SYDNEY CENTRAL CITY PLANNING PANEL

COUNCIL ASSESSMENT REPORT

Panel Reference	PPSSCC-202
DA Number	DA/751/2019/A
LGA	City of Parramatta Council
Proposed Development	Section 4.55(2) modification to approved 3 storey high technology industry building and concept approval for a Stage 2 building, specifically revised building footprints/layouts, materials, equipment and landscaping.
Street Address	8 Grand Avenue, ROSEHILL NSW 2142 (Lot 2 DP 1258587)
Applicant	Equinix Australia Pty Ltd
Owner	Grand 4 Investments Pty Limited
Date of lodgement	16 December 2020
Number of Submissions	None
Recommendation	Approval subject to revised conditions
Regional Development Criteria	The proposal is a s4.55(2) modification to an application with a capital investment value of more than \$20 million (criteria at time of lodgement) and the application includes new elements which exceed a development standard by more than 10% (height).
List of all relevant s4.55(1)(a) matters	<ul style="list-style-type: none">• Environmental Planning and Assessment Act 1979• Environmental Planning and Assessment Regulations 2000• State Environmental Planning Policy (State and Regional Development) 2011• State Environmental

Installation of new platform between Building A and Generator Building

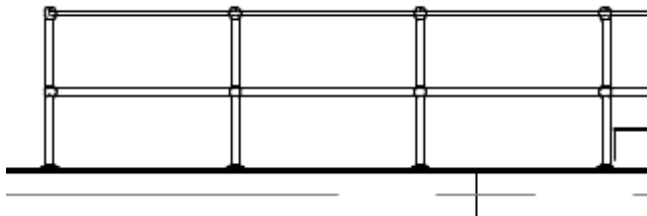
The proposal seeks to include a secondary platform/gantry above the existing approved first floor gantry around the plant area immediately to the west of Building A. The gantry is at a

height of 9m and as such complies with the height limit. The gantry is primarily internal to the space between the plant and Building A and as such will not be readily visible from surrounding properties or the public domain. The gantry is sufficiently separated from the boundaries so as not to result in any privacy conflicts. As such the modification is considered to be acceptable.

Introduction of external exhaust to Generator Building

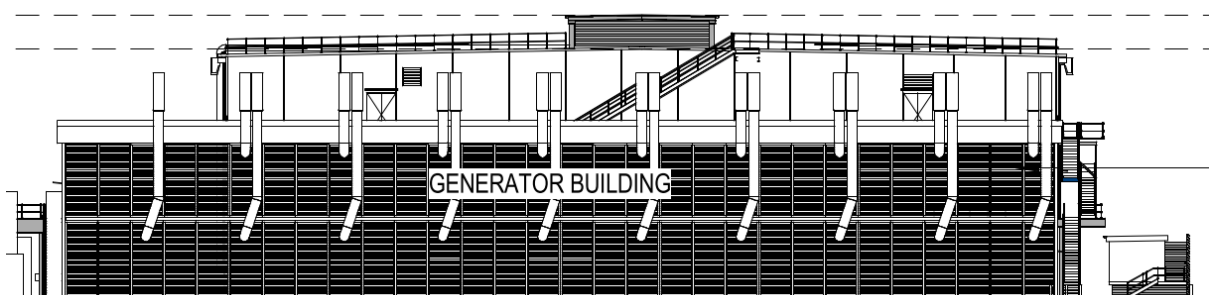
The proposal includes the introduction of 19 external exhaust vents on the southern elevation of the Generator Building. The vents exceed the height limit, but would be subsumed by the larger Building A. The exhausts are considered to be compatible with the industrial character of the area and as such are acceptable. The proposal results in no change to the generator capacity of the building and as such there are not considered to be any additional environmental impacts than originally approved.
